v3.1.1 UI/UX Updates

Feature Set Proposal for Summative Usability Study

MC2 App - Error Messages

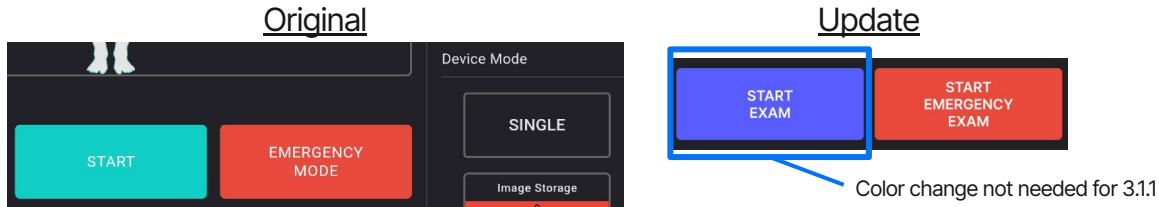
- Implement language in error messages that a lay-user can understand
 - These are specifically the error messages that pop-up at the top-center of the screen and then populate the Notifications tab
 - It may not always be possible to explain to the user what is wrong, but it is more important to convey what the user should do

Exam Setup Page - Start Exam Buttons

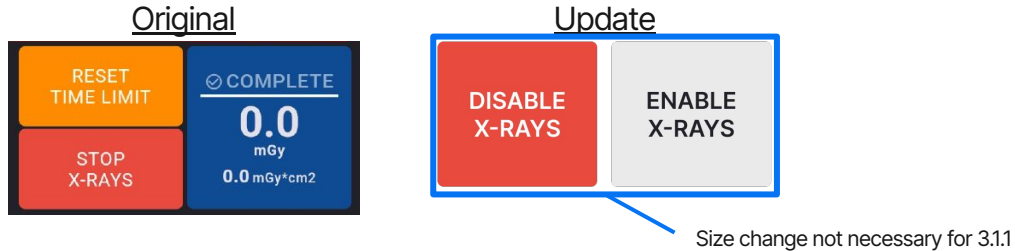
- Update the button text from "START" and "EMERGENCY MODE" to "START EXAM" and "START EMERGENCY EXAM"

- Addresses usability issues from previous usability studies; needs to be validated
 - Some users were not sure how to begin an emergency exam, confused by the choice of wording
- Should be a low effort change

Acquisition Page - Irradiation Disabling Switch

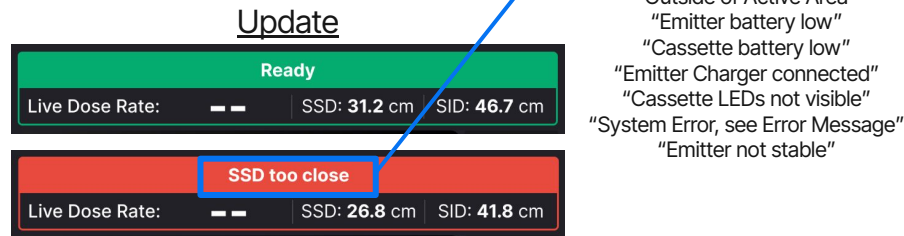
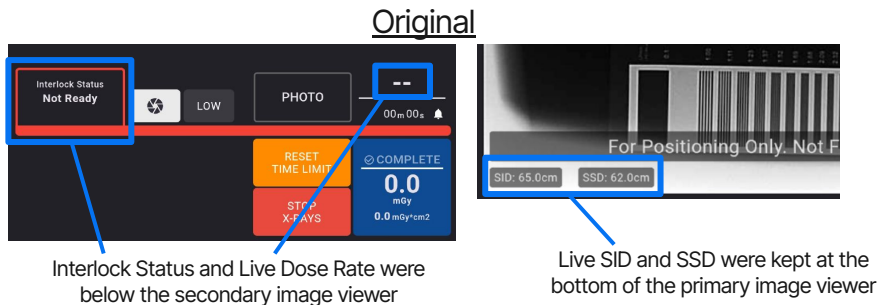
- Update the button text from "STOP X-RAYS" and "ALLOW X-RAYS" to "DISABLE X-RAYS" and "ENABLE X-RAYS"

- Addresses usability issues from previous usability studies; needs to be validated
 - Some users were not sure how to end an exam, pressing "STOP X-RAYS" instead of "COMPLETE"
- Should be a low effort change

Acquisition Page - Live Status Widget

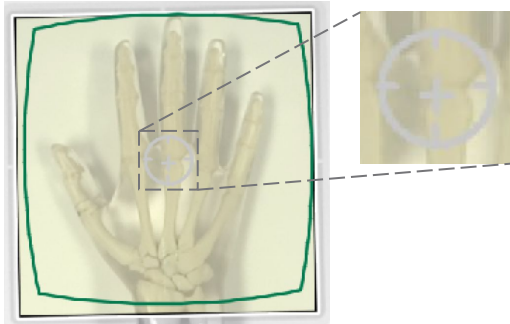
- Relocate Interlock Status, SSD, SID, and Live Dose Rate to a single widget above the secondary image viewer
 - This will also require the secondary image viewer to be resized
- When the device is Not Ready, display the interlock reason

- Relocating SSD and SID addresses usability issues from the bridge study; needs to be validated
- Relaying the interlock reason to summative usability participants will be key for troubleshooting tasks which is an **FDA concern**
- Relocating Live Dose Rate is less important, but fully represents the feature as it will be in 3.2

Viewfinder - Remove High-powered Singles (0.16, 0.25, 0.40) in DDR Mode

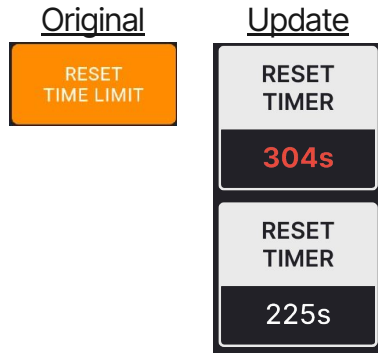
- Remove the ability to take 0.16, 0.25, and 0.40 mAs Singles in DDR
 - 0.08 would be the max mAs in DDR mode
 - Can still fire 0.04 and 0.08 mAs Singles by quickly pulling the trigger

- Both HF and Sales have observed that users are confused by the visual indication of this function
- With this, there are two potential hazardous situations that could occur:
 - A user thinks the white value corresponds to DDR and ends up taking a DDR that is lower quality than intended (**non-diagnostic exposure**)
 - A user tries to take a DDR, but releases the trigger too quickly and unintentionally takes a high-powered Single (**non-ALARA exposure**)
- HF has determined that it would be best to remove it
 - Trying to improve the visual indication just results in a more cluttered Viewfinder
 - After interviewing Sales, there doesn't seem to be a very likely use case for it
 - This function is also a hold-over from when MC2 only had one X-ray mode - it is now less applicable

Acquisition Page - Load Time Limit Reset Button

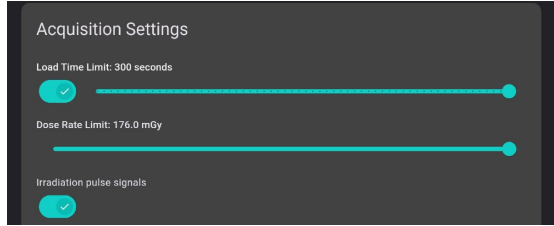
- Add a count-up timer to the button
 - The time will reset to 0s when the button is pressed (this differentiates it from the cumulative time, which will continue to count up)
 - The time will turn red when the loading time surpasses the set limit (which is a necessary visual if they have audible signals disabled)

- HF believes that adding an indication of the time will be useful for users that want to use this function
 - This will let them know how much time they have left
- Adding this feature has the potential to introduce confusion, so it needs to be validated

Cassette Settings - Acquisition Settings

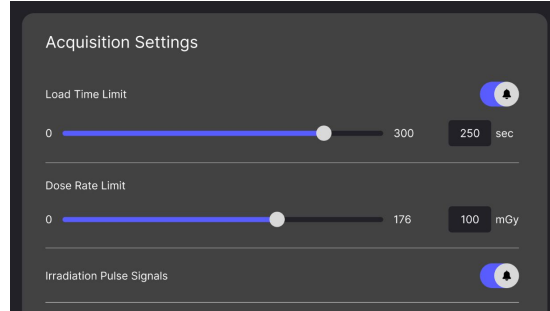
- Add min and max values to limit sliders
- Add free-entry field alongside limit sliders
- Change check icon to bell icon

- Addresses usability issues identified in previous formative usability studies; needs to be validated
 - It was difficult for users to set a specific value using the slider
 - Some users were not aware that the toggles serve to mute the associated audible signals
